MS9446
AMENDMENT 1
8 JULY 2003

MILITARY STANDARD

BOLT, MACHINE - STEEL AMS 6304, DIFFUSED NICKEL-CADMIUM PLATED,
HEXAGON HEAD, DRILLED, .5625-18 UNJF-3A

This amendment forms a part of MS9446, dated 21 December 1962, and is approved for use by all Departments and Agencies of the Department of Defense.

Sheet 1

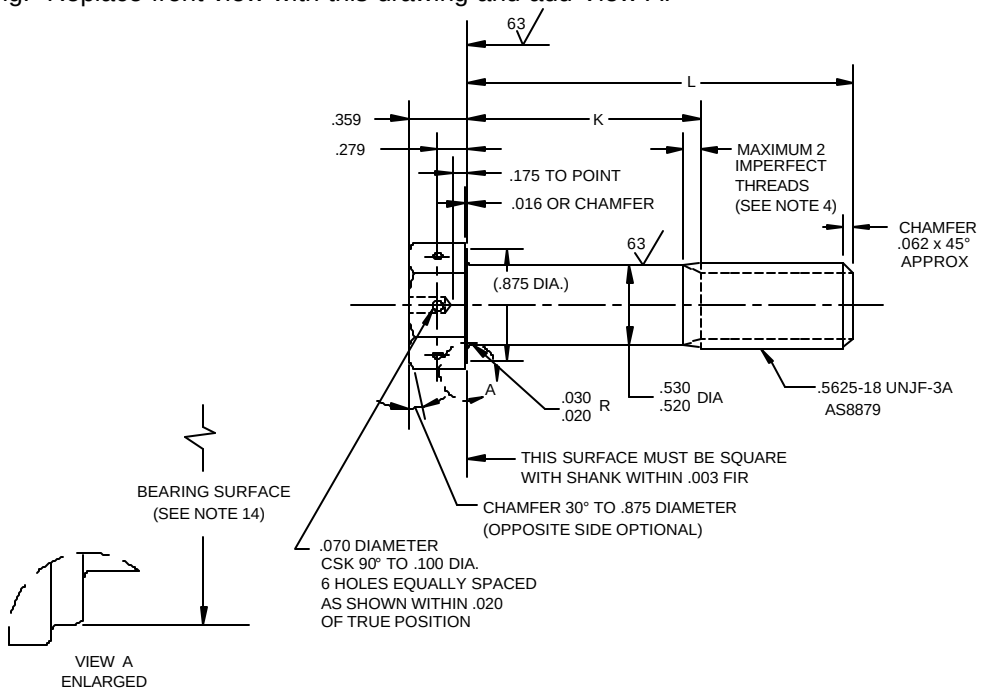
In drawing: Replace front view with this drawing and add View A.
